Anonymous Referee #2

Received and published: 29 October 2018

General comments: The authors quantified the annual impacts of discharge and vegetation density on the sediment concentration at dozens of gauges over the Yellow River basin. The conclusion is that the dominant controlling factor of sediment shifts from discharge to the vegetation resistance with discharge increasing, which is interesting. Besides, the manuscript was well written. However, some problems about the details of the assumptions and method used (i.e. wavelet coherence analysis and regression fitness) are expected to be explained more clearly, as these details are very critical to the reliability as well as reasonableness of results associated with main conclusion.

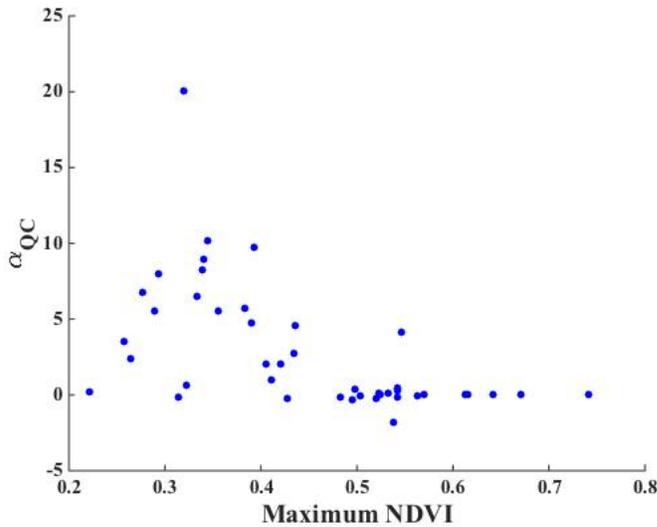
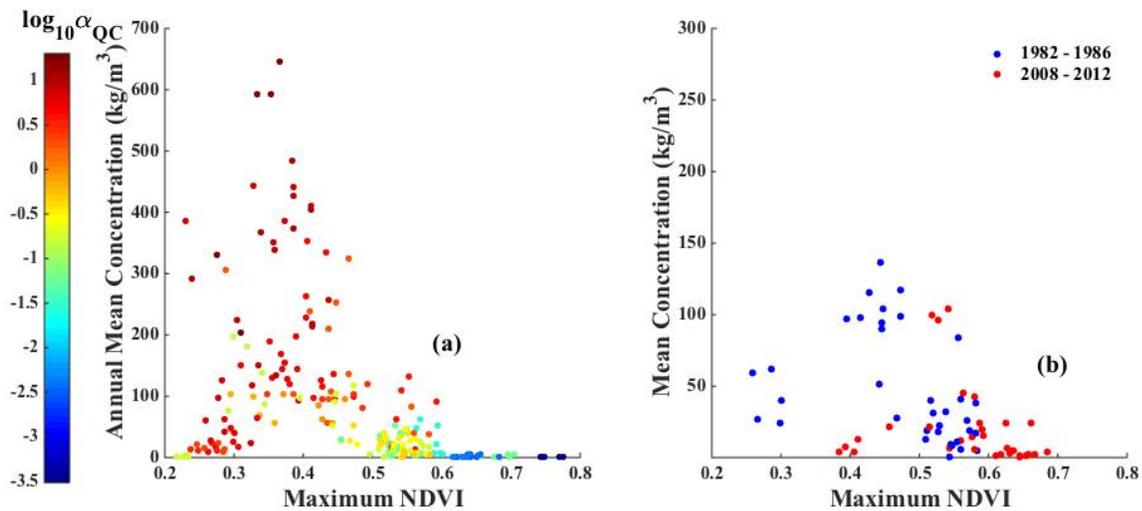
(1) "The sediment concentration follows a bell shape with NDVI at annual scale" was summarized throughout the text (e.g., Line 12/193/253), while the log-transformation was used to sediment concentration data in Figures 2 and 3. As we know, the log transformation is non-linear, thus the bell shape in Figures 2 and 3 may depend on this transformation approach.

We agree with the reviewer that log-transformation would change the shape of the correlation between NDVI and concentration. But as we shown here the increase and decrease trend of the bell shape sustains and is clear in linear scale. As the concentration covers a large range from 0.1kg/m^3 to 700kg/m^3 , the points with small concentration (i.e. $\leq 100\text{kg/m}^3$) would all collapse. The differences among these points cannot be shown clearly in linear scale. Thus, to make the relationship clearer we choose the log-transformation for better presentation. We hope the reviewer finds our explanation satisfactory.

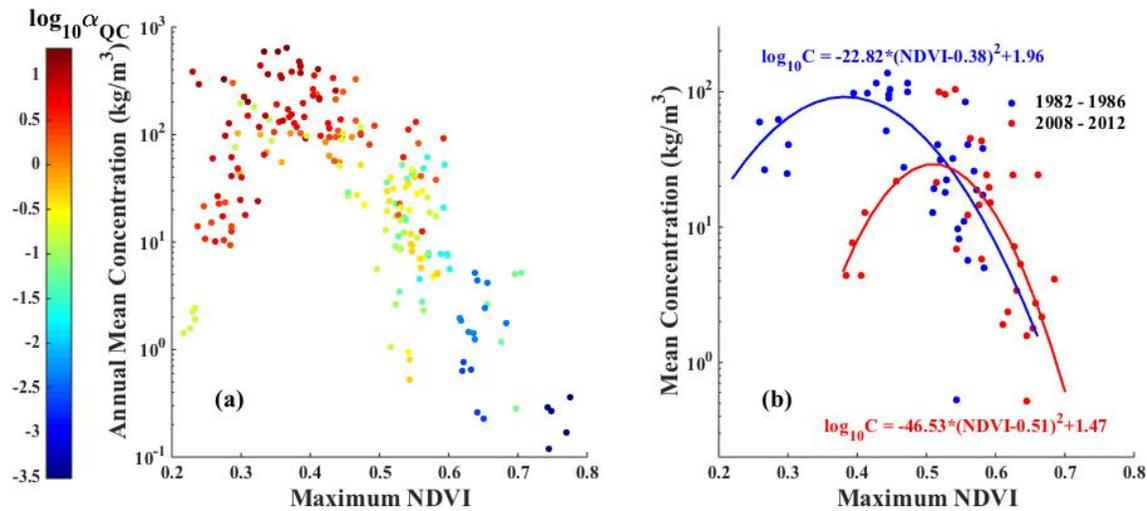
(2) In Figure 3, the authors should give the mathematical expression of the fitted curve with bell shape. Is it of a polynomial form or something else? Moreover, the goodness of the fit is expected to be presented.

Yes, it is a polynomial form. We have now shown the mathematical expression of the fitted curve, as well as the goodness of the fit in the figure. Thank you for your suggestion (please see the updated Figure 3).

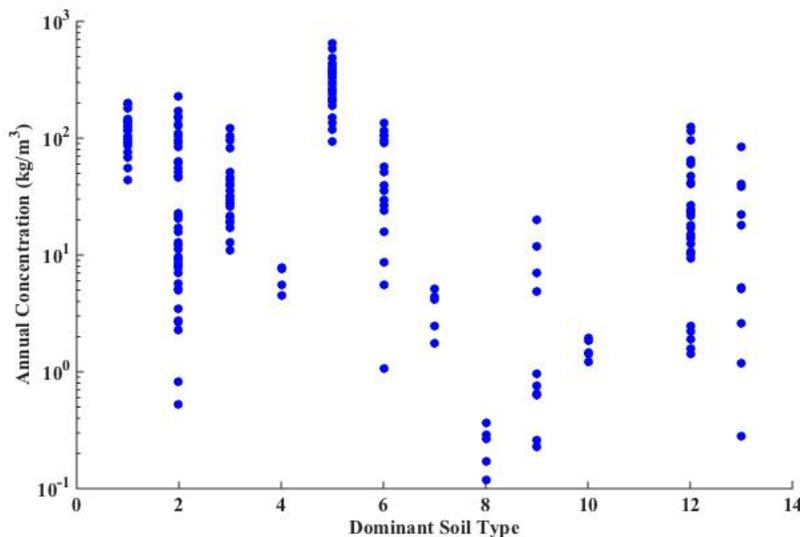
(3) It's doubtful that the so-called emergent stationarity is attributed only to vegetation resistance. The physical connection between vegetation condition and sediment concentration is not as explicit as that between discharge and sediment concentration. In addition, the discharge and the vegetation were separately incorporated to consider the impact to sediment condition. So, the conclusion in this study is under very strong assumption, i.e., the sediment condition in a basin is only controlled by discharge and vegetation. However, this assumption was not listed clearly. On the other hand, was it reasonable? In addition to vegetation, resistance of sediment to erosion may be related to other property of the basin, such as soil properties. Authors said sediment concentration follows a bell shape with vegetation index. I guess that the mean sediment concentration also follows a bell shape with the mean runoff. According to literatures, the discharge of 1982-1986 in many sub-basins of Yellow River was much larger than that in 2008-2012, how to compare the decreased discharge contribution with the increased NDVI contribution to the concentration? Can the authors add the plot of mean sediment concentration against annual discharge with the same period and gauges in both Figure 3a and 3b?

We have also studied the correlation between dominant soil types and sediment concentration, the plot is quite scatter, thus we didn't show it in the manuscript for brevity. The results is shown in Figure R1. It is possible that there are other factors we did't consider here that influences the sediment transport, however, given the good fit between maximum NDVI and concentration, it is reasonable to say that vegetation plays an significant role in the soil erosion and sediment transport in the YRB, though it may not be the only controlling factor.

L229: To confirm this impact of vegetation resistance, we also examined the relationship between sediment concentration and other catchment characteristic like dominant soil type. No significant correlation was observed as vegetation did. Although there could still be other factors not considered here contributed to the decline in sediment concentration, it is undoubted that vegetation is one of the most influential factors of sediment reduction and can be used as a good indicator of the soil erosion and sediment transport in the YRB.

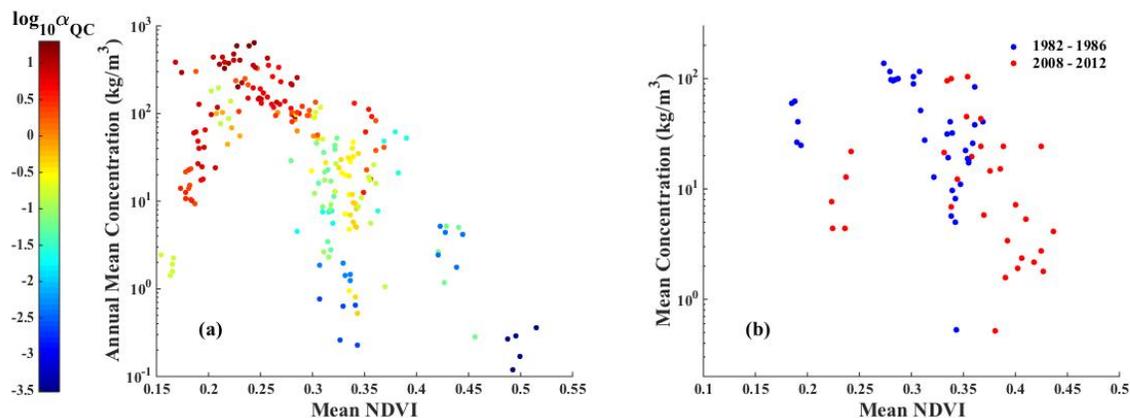
(5) Why not use the mean NDVI, but the maximum (daily?) NDVI, when you investigated the relationship between the NDVI and mean concentration at annual scale? How much uncertainty for the maximum NDVI exists?

We tried the mean NDVI as well, the rising and falling trend is still apparent (see following figure), but the maximum NDVI provides better shape. Thus, we chose to use the maximum NDVI for presentation. One possible reason is that the vegetation types in the YRB are mostly deciduous, the green period is relatively short, an averaged NDVI could decrease the difference among vegetation density. Since the variability in maximum NDVI for each site is not very large (Figure 3a), and the trend is consistent between mean NDVI and maximum NDVI, we think the uncertainty for the maximum NDVI is not significant for this study. We hope the reviewer finds our explanation sufficient.

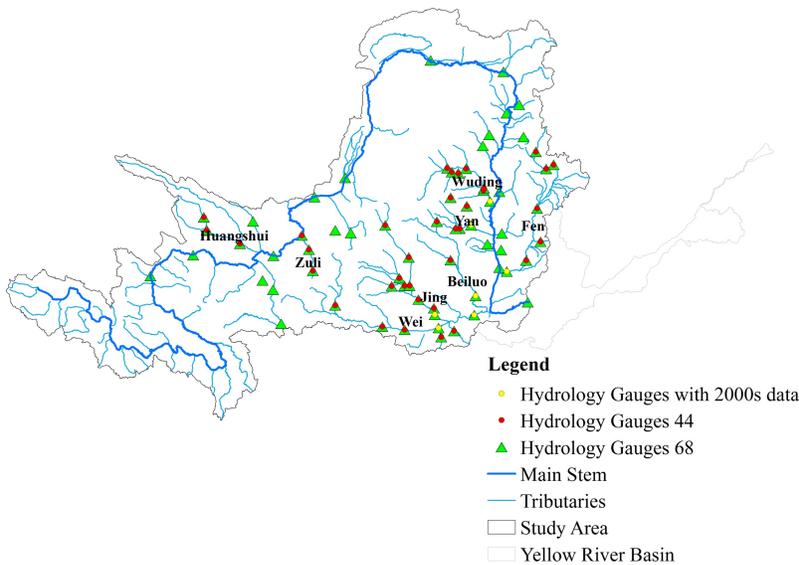
(6) In Figure A1, the text in legend is inappropriate, because there were not 68 green triangles plotted (maybe 68-44=22 gauges).

Since the 44 gauges belongs to the 68 gauges, it might be confusing to use 22, we have changed the symbol to make it clear. Hopefully the reviewer finds the updated figure appropriate.
